Service Bulletin No. 3072

MODEL D Series Coaches	TYPE Product Improvement	SECTION/GROUP 7 – Electrical	DATE Aug. 3, 2012
SUBJECT ALLISON TRANSMISSION HARNESS ROUTING AND LOOM			
CONDITIONS Parts may be purchased from MCI Service Parts, Louisville, Kentucky.

Figure 2.

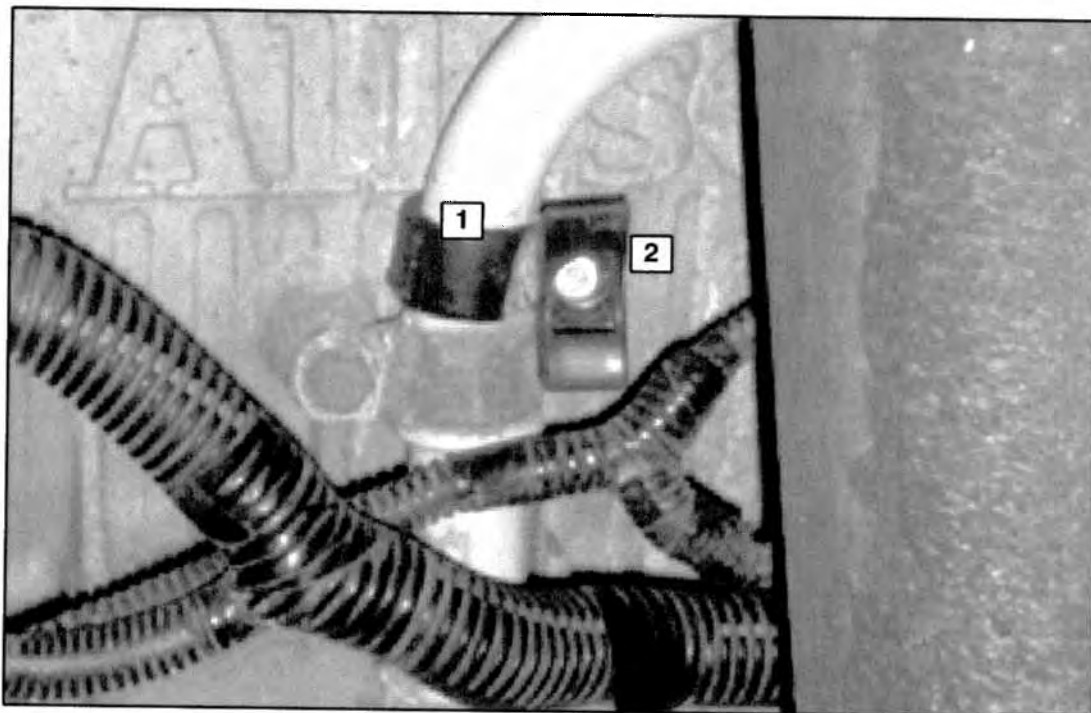
4. Using the p-clamp removed in Step 3. , mount the tie base, p/n 07-08-4525, using hardware p/n's 19-1-825, 19-3-228, 19-02-6063 and 19-02-6035 (refer to Figure 2).

ITEM	DESCRIPTION
1	Existing p-clamp removed in Step 4
2	Tie base, p/n 07-08- -4525

Figure 3. Tie base installation.

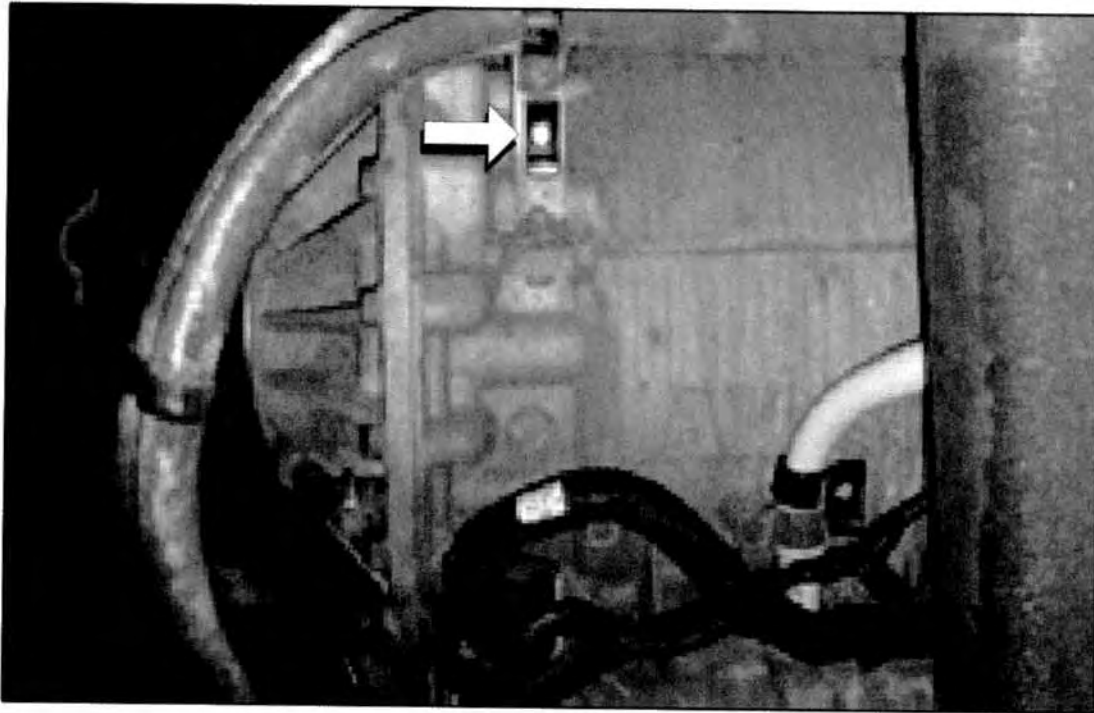
5. Orient and mount the tie base, p/n 07-08-4525, using hardware p/n's 19-1-825, 19-3-228, 19-02-6063 and 19-02-6035 at the locations shown in Figures 3, 4 and 5.

Figure 6.

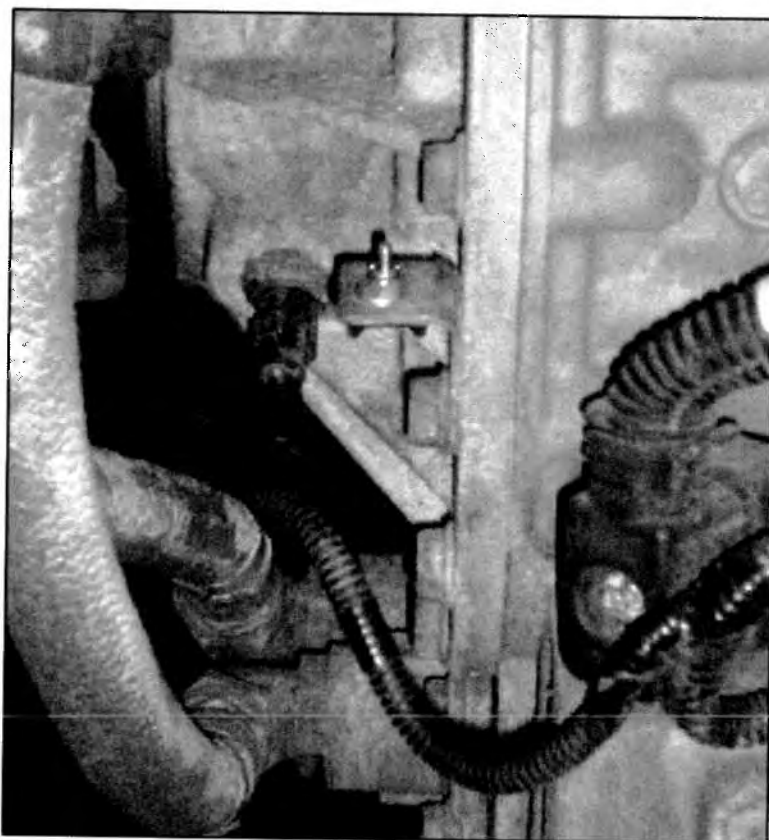
6. Orient and mount the tie base, p/n 07-08-4526, using hardware p/n's 19-1-694, 19-3-111, 19-2-73 and 19-2-19 at the location shown in Figure 6.

Figure 7.

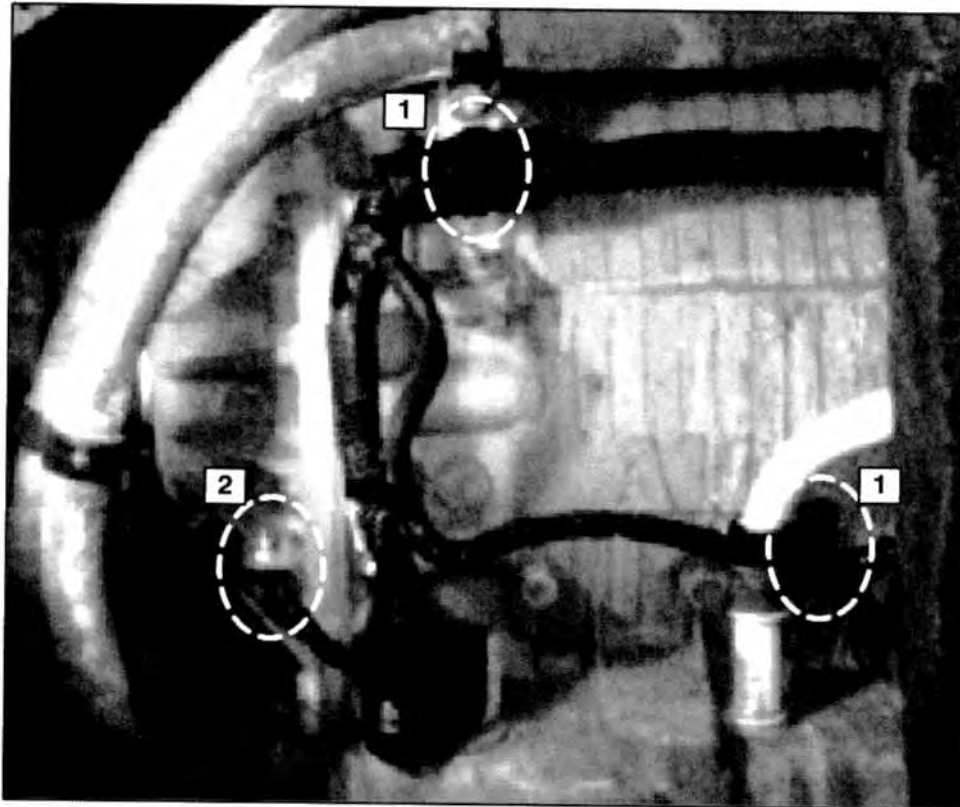
7. Route and secure the harness as shown in Figure 7.

<u>ITEM</u>	<u>DESCRIPTION</u>
1	Secure harness using p/n 07-08-4527 and 07-08-4535
2	Secure harness using p/n 19-11-258

Figure 8.

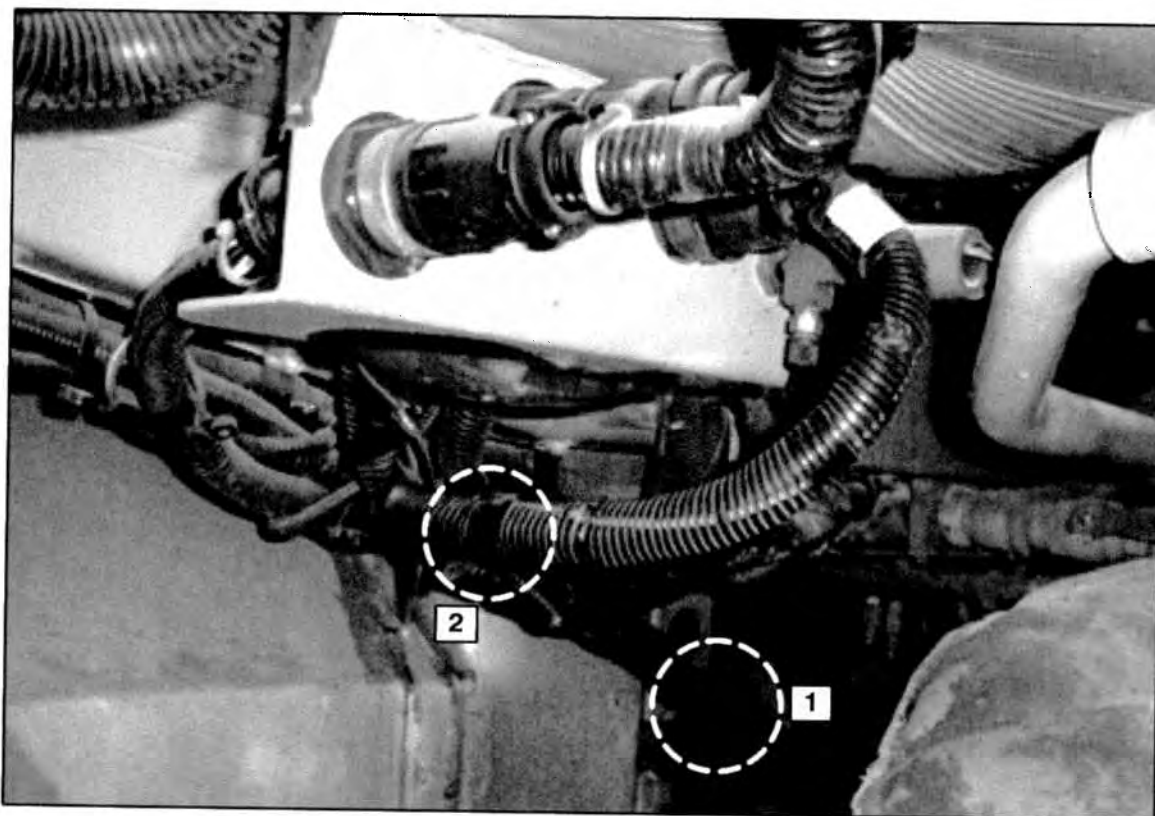
8. Route and secure the harness as shown in Figure 8.

<u>ITEM</u>	<u>DESCRIPTION</u>
1	Secure harness using p/n 07-08-4527 and 07-08-4535
2	Secure harness using p/n 07-08-4527 (2).
